Fresno to Bakersfield Revised Draft EIR/Supplemental Draft EIS Comment
770 L Street, Suite 800
Sacramento, CA 95814

RE: Revised Draft EIR/Supplemental Draft EIS Comment – Fresno to Bakersfield

To: Gary A. Patton, Of Counsel
Wittwer & Parkin, LLP
From: Will Washburn, PE *WW*
Subject: California HST Project Revised DEIR/Supplemental DEIS
Fresno To Bakersfield Section
Date: October 17, 2012

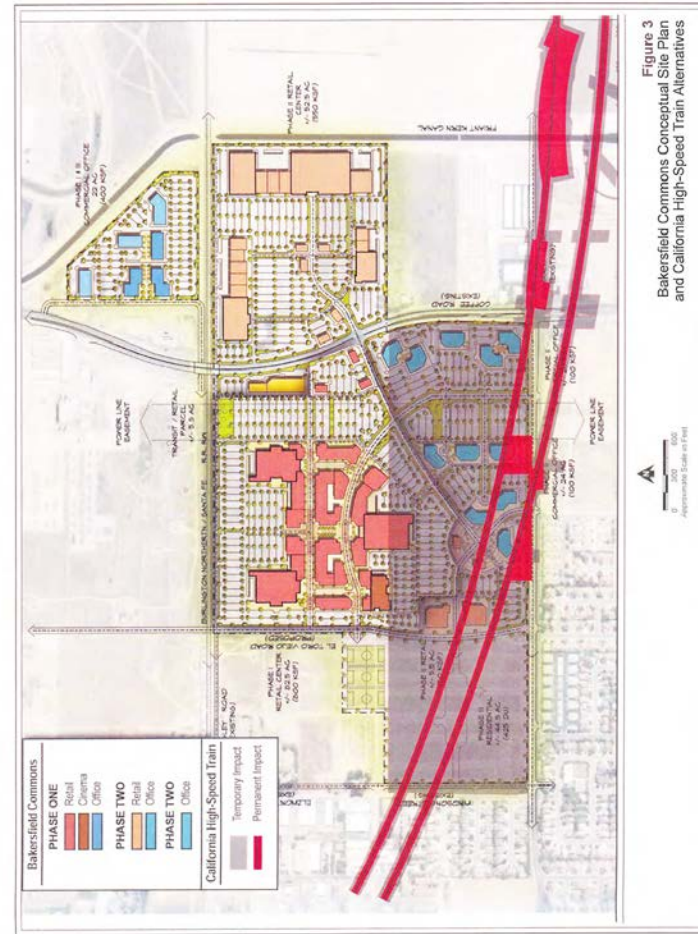
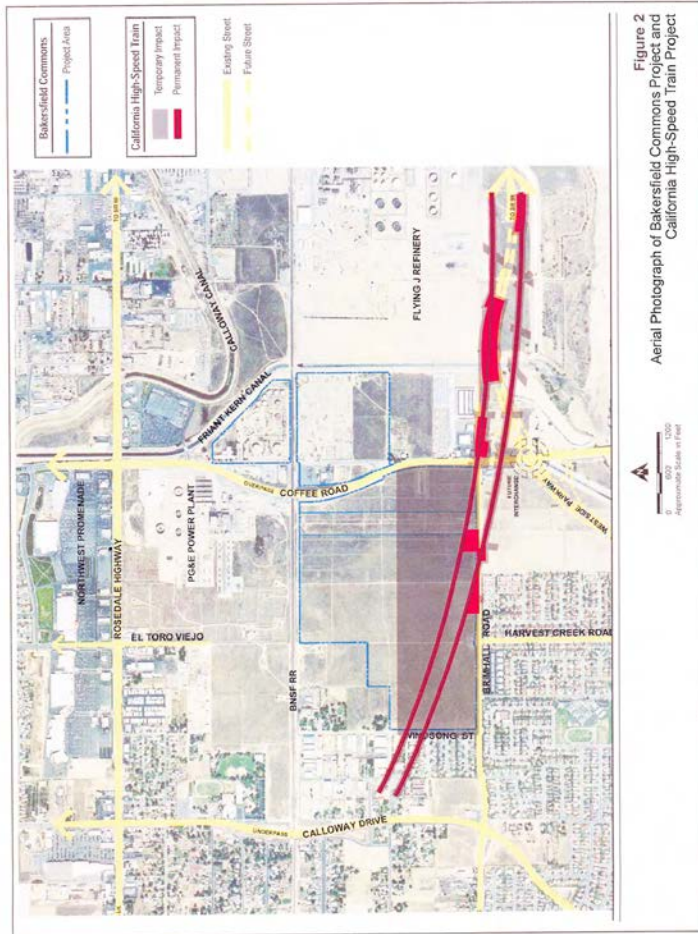
With regard to the HST Project, all of the alternatives analyzed in the EIR/EIS cross the Bakersfield Commons site. In proximity of the Bakersfield Commons site, the alignments for the Bakersfield South and the Bakersfield Hybrid Alternatives are the same. As such, while the EIR/EIS discusses three alternatives in the Fresno to Bakersfield section of the Statewide High-Speed Train project, in actuality there are only two alignments. Further, these two alignments are similarly situated as they are located only a few hundred feet apart as they bisect the southern portion of the Bakersfield Commons site. Refer to Figure 2 and Figure 3 on pages 5 and 6, respectively, as well as Sheets 270 and 272 of Appendix 3.1-A of the EIR/EIS (which are presented in Appendix A to this comment letter) regarding the location of the Bakersfield South/Bakersfield Hybrid and BNSF Alternatives relative to the Bakersfield Commons project. Across the Bakersfield Commons site, the Bakersfield South/Bakersfield Hybrid and BNSF Alternatives are proposed in an aerial alignment that rises between 60 and 82 feet above existing grade (see Drawing Nos. CB0770 and CB0771 of Volume 3, Section B of the EIR/EIS which are presented in Appendix B to this comment letter). With the addition of the HST Project's proposed sound wall, the height of the aerial guideway across the Bakersfield Commons site increases to 74 to 96 feet above existing grade.

Table 1
 Impacts of Proposed High Speed Rail Alignments to Bakersfield Commons Site
 (Acres Impacted)^a

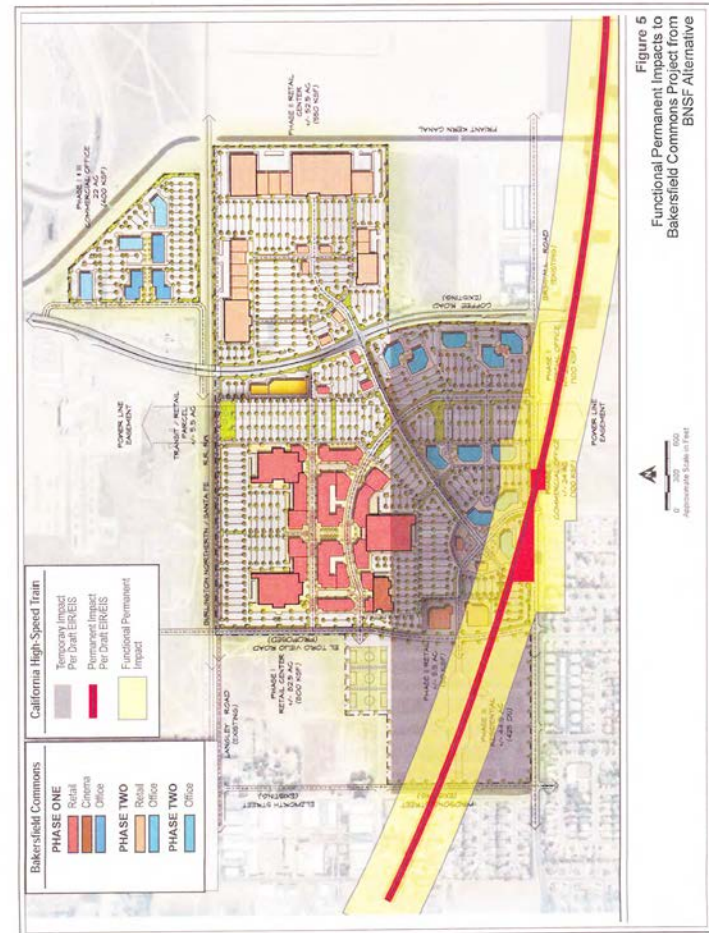
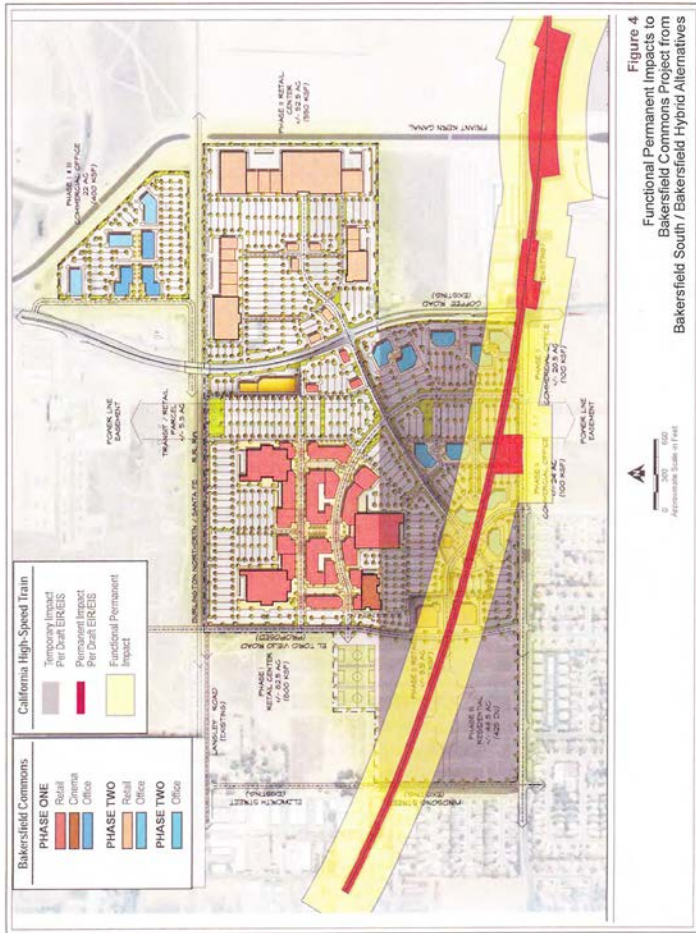
height (which includes the proposed sound wall) that towers over and bisects the Bakersfield Commons residential development area (see Figure 3 and Figure 5 on pages 6 and 10, respectively). These impacts would, in essence, eliminate the market viability of developing residential uses in this area.
